MINERALS PROGRAM INSPECTION REPORT

MINE NAME: Ragsdale Reservoirs	MINE/PROSPECTING ID#: M-2020-007	MINERAL: Gravel, sand and borrow material	COUNTY: Weld
INSPECTION TYPE: Surety Release Inspection	WEATHER: Clear	INSP. DATE: July 16, 2024	INSP. TIME: 10:00
OPERATOR: L. G. Everist, Incorporated	OPERATOR REPRESENTATIVE: Lynn Mayer Schults	TYPE OF OPERATION: 112c - Construction Regular Operation

Image 3: Google Imagery depicting permitted area and mining phases. Image dated 9/4/2023.

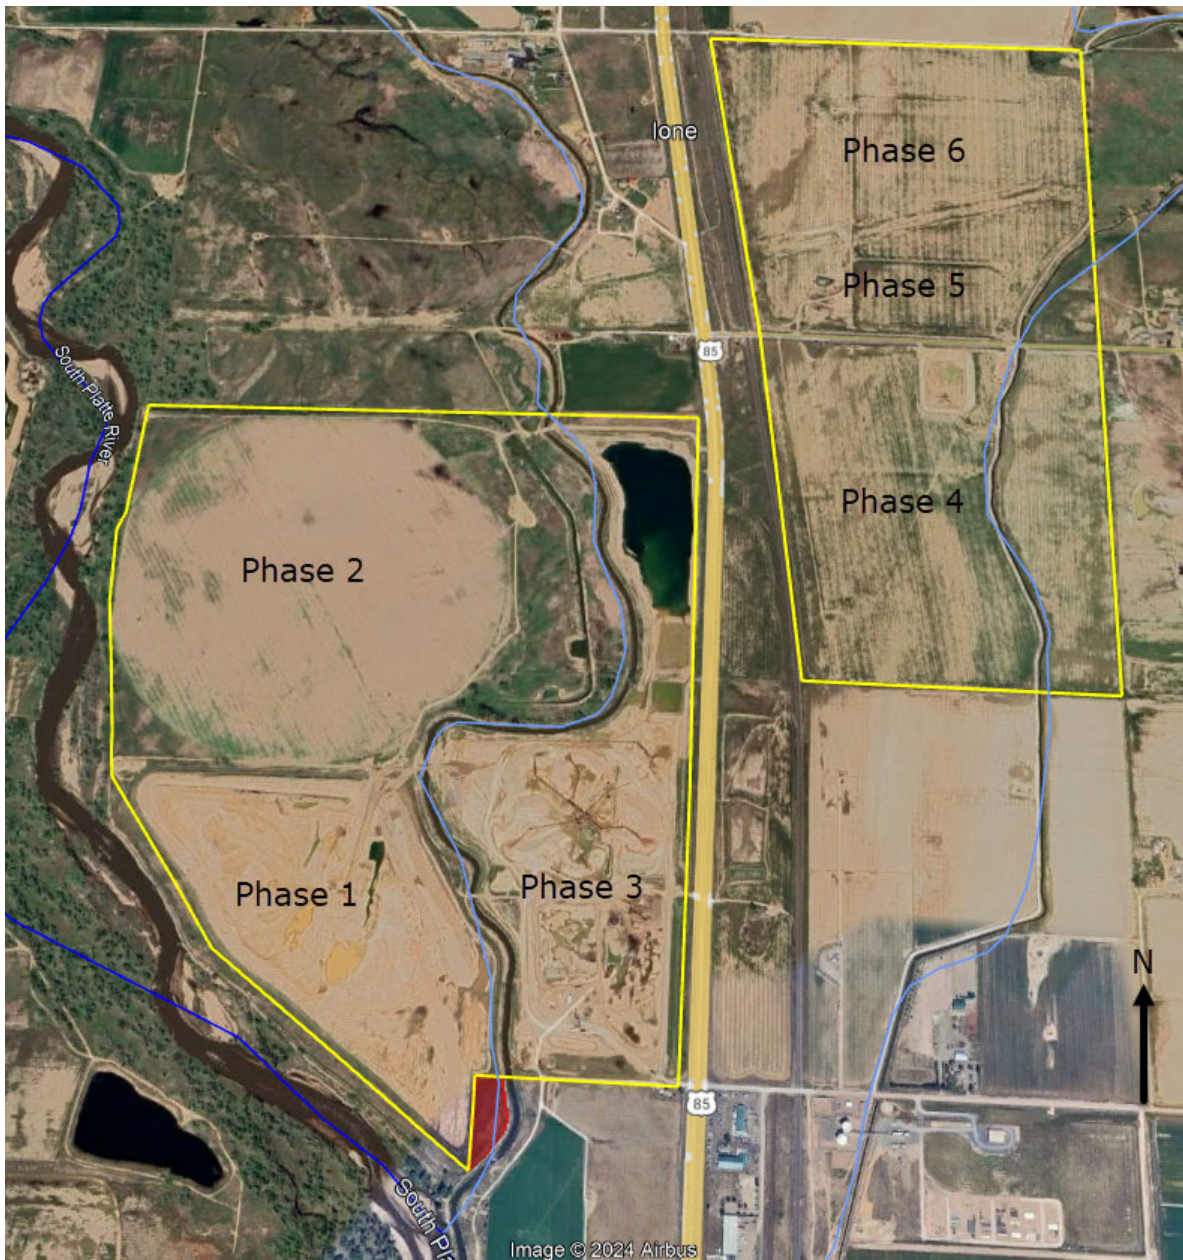
The Division observed the Phase 1 and Phase 2 mining areas on the west side of the permit area. Mining is nearing completion in Phase 1 and LGE has started on reclamation of the slopes around the reservoir. During this inspection, the Division observed mining equipment operating in the bottom of the reservoir. A slurry wall is installed around the perimeter. The Operator is in the process of conducting a leak test to certify the liner. The side slopes of the reservoir are graded to 3H:1V slope and topsoiled in preparation for seeding. Approved concrete rip rap, approximately 12-24" in size, mixed with finer material, was observed placed along the western side slopes of the reservoir. Per the approved reclamation plan, a section of the rip rap on the south end of the reservoir was covered with topsoil. The Operator discussed removing this requirement to topsoil the concrete rip rap from the reclamation plan. LGE plans to submit an amendment to the Division for a future conveyor belt running from the Phase 3/Plant Site on the west side of the permit area to the east side of Highway 285. The Operator could either submit a Technical Revision to propose a new reclamation plan for the western slopes of the Phase 1 reservoir or include this change in the upcoming amendment application.

The Division viewed the slurry wall recently installed around the perimeter of the Phase 2 area. Additionally, the Operator pointed out that the oil and gas wells depicted on the mining and reclamation maps in the Phase 1 and Phase 2 areas have been removed, along with the associated gas lines. The Operator should depict this change on the mining and reclamation maps in the next technical revision.
